Ref: FCC Class II Permissive change for FCCID: [2BB64CQS290](#),

Applicant: [Cavli Inc.](#)

This is to request a Class II Permissive change for FCCID: [2BB64CQS290](#) originally granted on [06/27/2025](#).

① Below listed are the changes in CQS290 from certificated HW version 2.2 to New HW version 3.0

Figure 3. V3.0

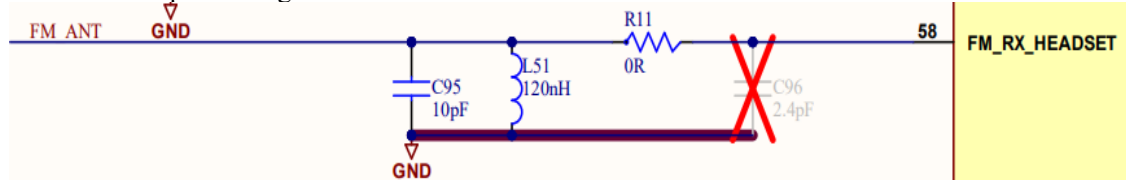
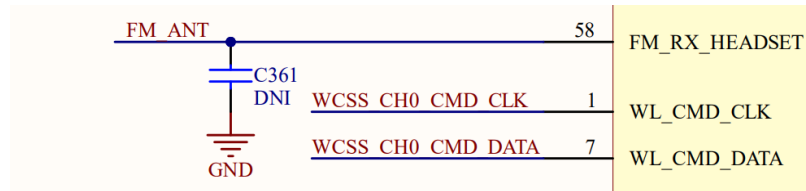
2. C287, C288 changed from 18pF to 1.6 pF (C67, C68).
3. FM antenna path changed.

Figure 6. V3.0

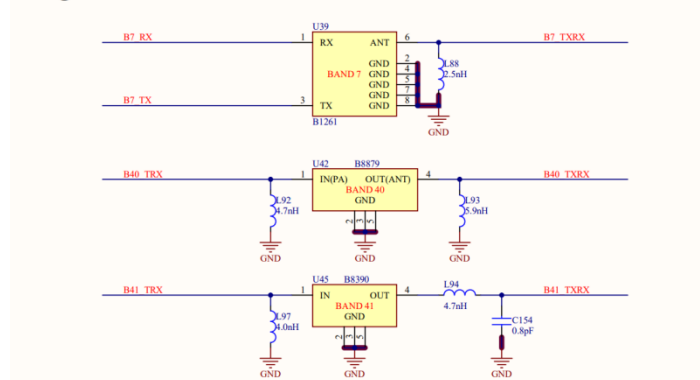
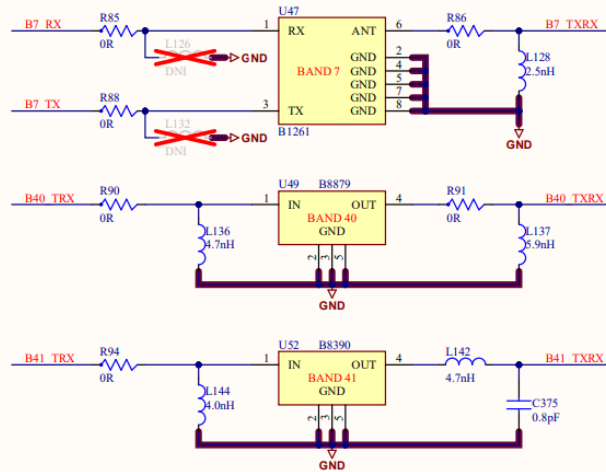
1. L-matching added for B7 Duplexer, B1261. ( added series 0ohm and shunt DNI )
